Group:	17-Intake and Exhaust
Bulletin No.:	SB-15-017
Issue Date:	03-06-2015

## 08MY-10MY J05 Broken Exhaust Manifold Studs

*Supersedes SB-11-001 dated 7-21-2011*

New parts are available to prevent repeat exhaust manifold stud failures on the J05 engine. This bulletin provides instructions for an exhaust manifold attachment modification at the #1 and #4 cylinder locations. Modifications to the manifold insulator shield and the turbocharger water return pipe have also been made to accommodate the longer studs.

### Stud Locations

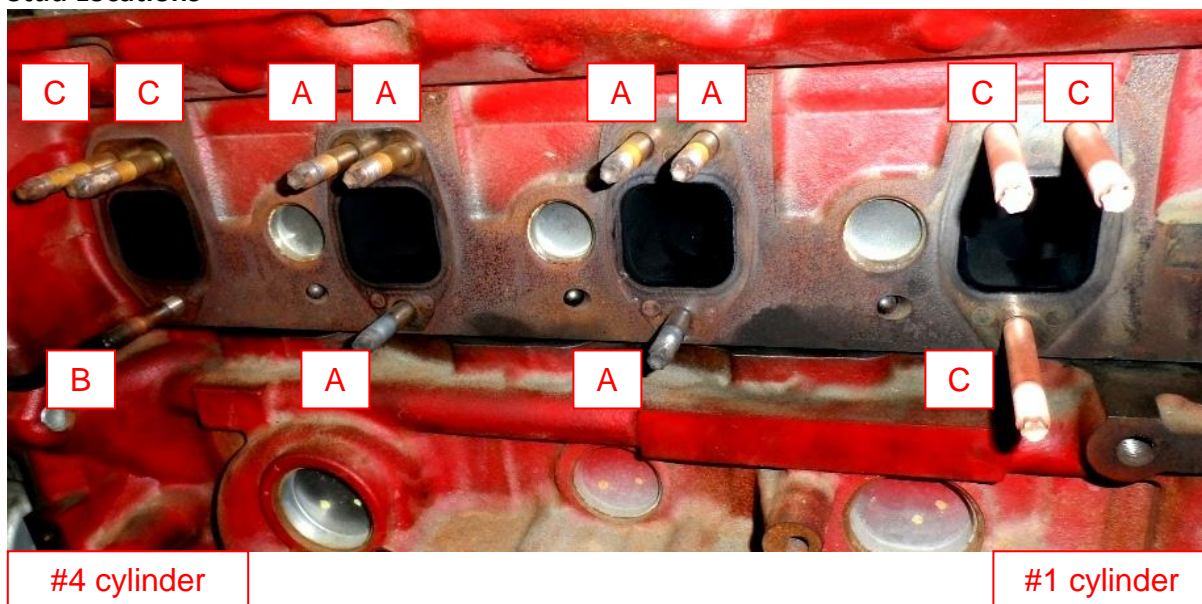
**NOTICE:** There are three different lengths of the studs to be installed in the cylinder head. Be sure to install each stud in the correct location.

**3.** Install the new studs into the cylinder head as shown in the photograph below. Reference the table below for the correct stud location. Tighten the studs to the specified torque.

**Specified Torque:** 22 lb-ft (30 Nm)

Location	Stud	
	Part Number	Length
A	SZ12610012	56 mm
B	SZ12610006	67 mm
C	SZ12610009	96 mm

### Spacer Locations

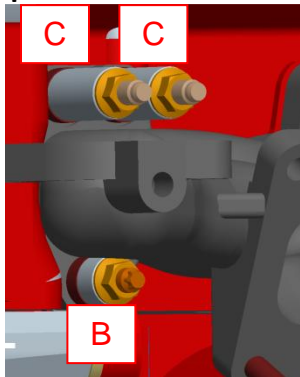
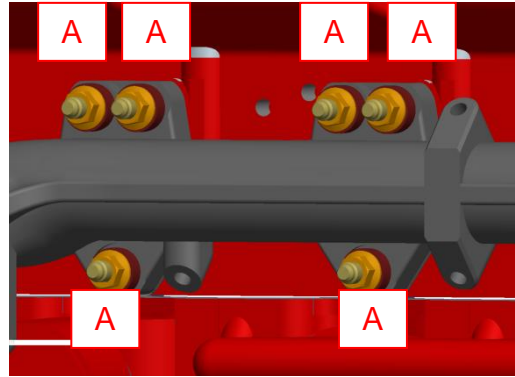
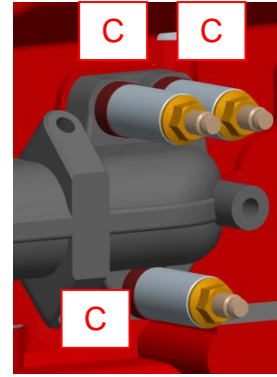
**NOTICE:** There are three different lengths of the spacers to be installed. Be sure to install each spacer in the correct location.

Install the spacers as shown in the illustration below. Refer to the table below for the part number of each spacer. Install the 14mm nut (SZ17810007) onto each of the studs, and tighten the nuts to the specified torque following the torque sequence outlined in the workshop manual. Once all 12 nuts have been torqued to specification, re-torque them again in the same sequence.

**Specified Torque:** 43.5 lb-ft (59 Nm)

Location	Spacer	
	Part Number	Length
A	SZ91016217	8 mm
B	17444E0060	20 mm
C	SZ91016297	45 mm

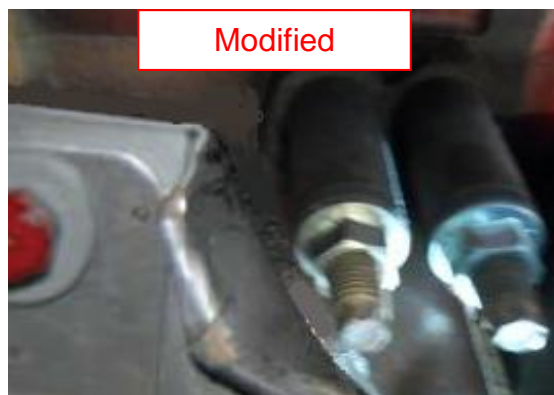
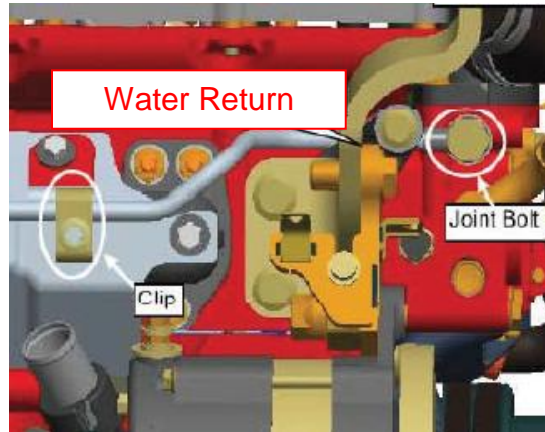
6. The original end of the exhaust manifold insulator shield will not allow proper clearance to the longer #1 exhaust stud spacers. If the insulator has not already been modified, the insulator will need to be bent downward to accommodate the longer studs on the #1 cylinder. Bend the corner of the shield downward to provide additional clearance for the #1 stud and spacer. Install the exhaust manifold insulator shield onto the exhaust manifold.

**NOTICE:** Do not cut the shield or bend the shield more than 4 times to prevent strength reduction. Also do not bend the shield in the opposite direction.
